Job	Truss	Truss Type	Qty	Ply	LOT 31 PROVIDENCE CREEK FUQUAY-VARINA, NC
24-0140-R01	R02RP2	Piggyback Base	8	1	Job Reference (optional)

REPAIR(S) REQUIRED

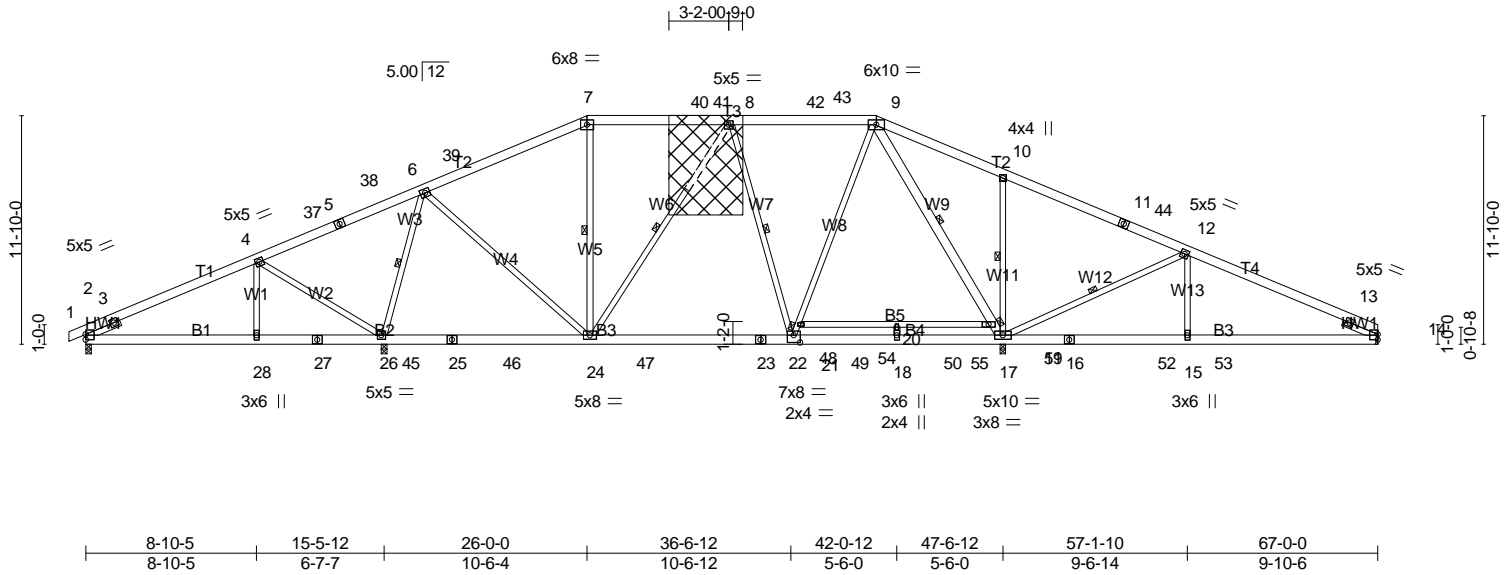
- NOTES-** (16-19)
 1) Repair Condition: web has damaged section 4-0-0 long starting 0-0-0 below joint 8.
 2) Replace damaged section cut clean with same size and grade of material. Attach 62"H X 46"W X 7/16" OSB (APA Rated Sheathing 24/16 Exposure 1) gusset to both sides of truss at joint 8 with 10d (0.131"x3") nails from each face, driven through both sheets of plywood and clinched. Connected together as follows: 2x6 - 2 rows 1-0-0 o.c., 2x4 - 1 rows 0-4-0 o.c. Minimum 0-3-0 end distance.
 3) Repairs specified by this program will be subject to review and change.
 4) Unbalanced roof live loads have been considered for this design.
